01 - 2010  
BDF453 / BDF453Z / BDF453H  
18V 1/2" DRIVER DRILL

**SERVICE CHANGES**

**1. Changes on Switch, Terminal, and Housing Set (Battery Protection Circuit)**

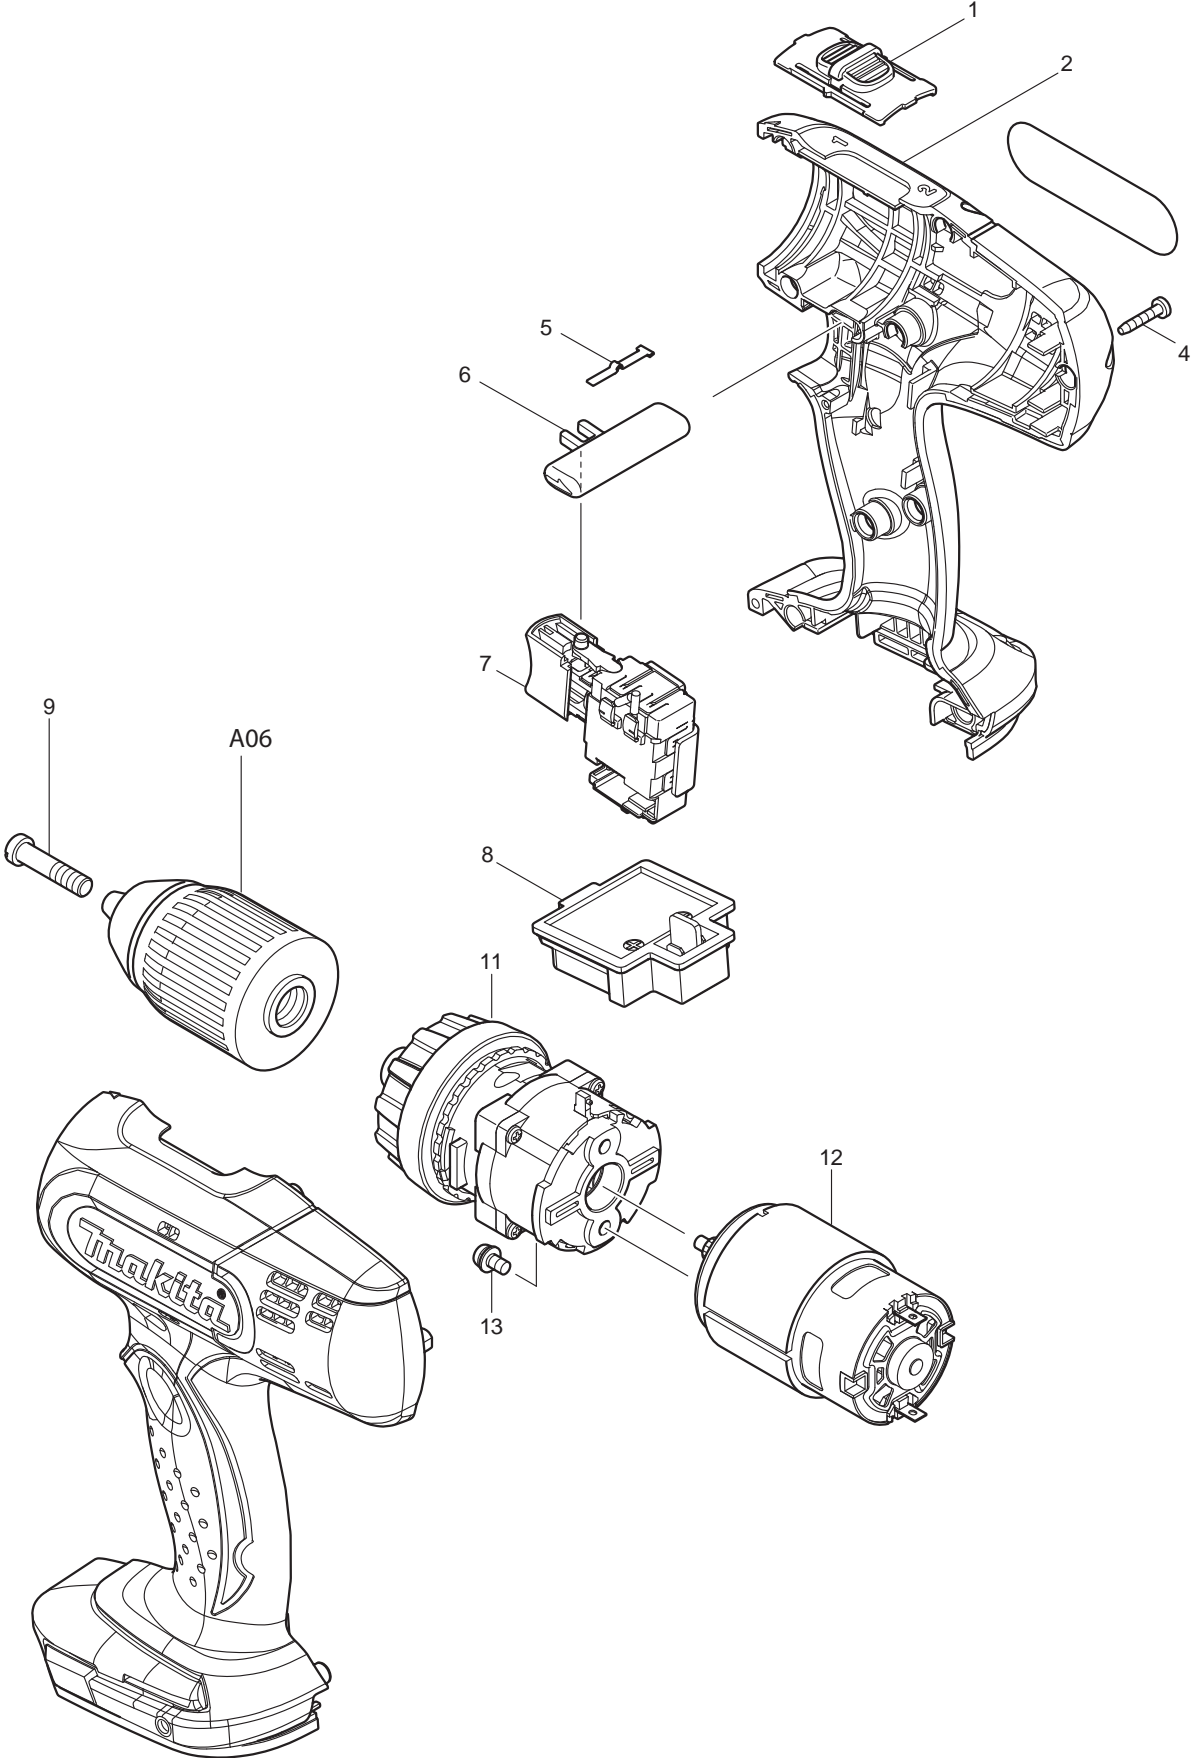
Item No.	Description	Type 1	Type 2	Type 3
2	HOUSING SET		188542-5	187363-2
7	SWITCH		650604-4	632A24-0
8	TERMINAL	643812-4	643844-1	643852-2

Above parts are completely interchangeable as a set.

- Use new parts for repair of the model manufactured on or after December 2011 with using Yellow lead wire between Switch and Terminal.
- Use current parts for repair of the model manufactured before December 2011 without using Yellow lead wire between Switch and Terminal.
